Project: PWD LNG - CANTILEVER BRIDGE

Title: BOX GIRDER GENERAL ASSEMBLY

Drawing No: 2019-026-D-0200 | Sheet: 3

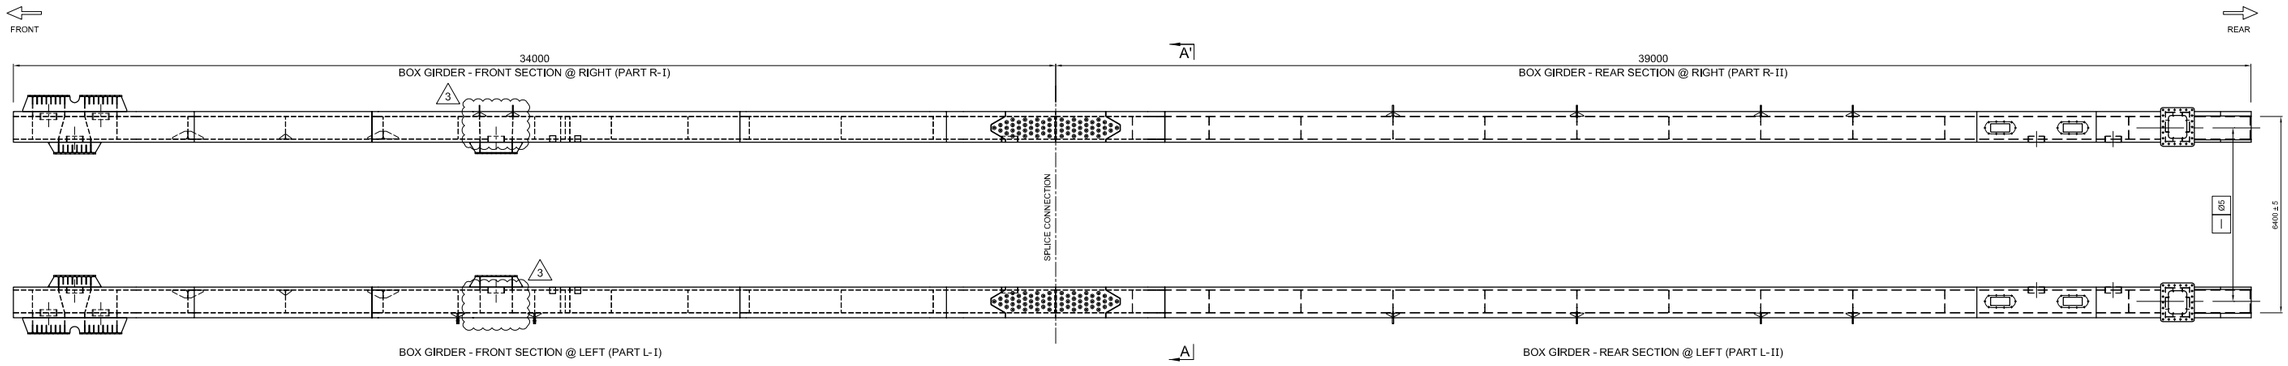
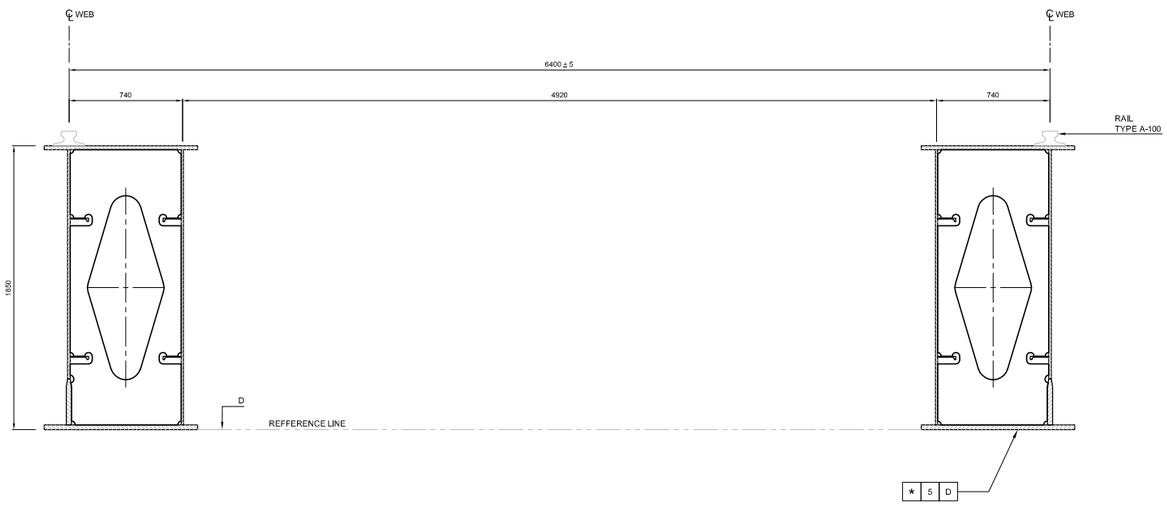
-REMOVED TEXT " * INDICATED PRE CHAMBER (ΔZ) VALUES ON HOLD"
-ALIGNMENT OF STIFFENER I.W.O TRANSVERSE BEAM CONNECTOR 2 IN BOX GIRDER @ LEFT
-ANGLE STIFFENER I.W.O TRANSVERSE BEAM CONNECTOR 2 AND HAMMER STAND IN BOX GIRDER @ RIGHT

-CHANGE THE VALUE OF PRE CAMBER LOAD
-ADDITIONAL VALUE OF STRAIGHTNESS
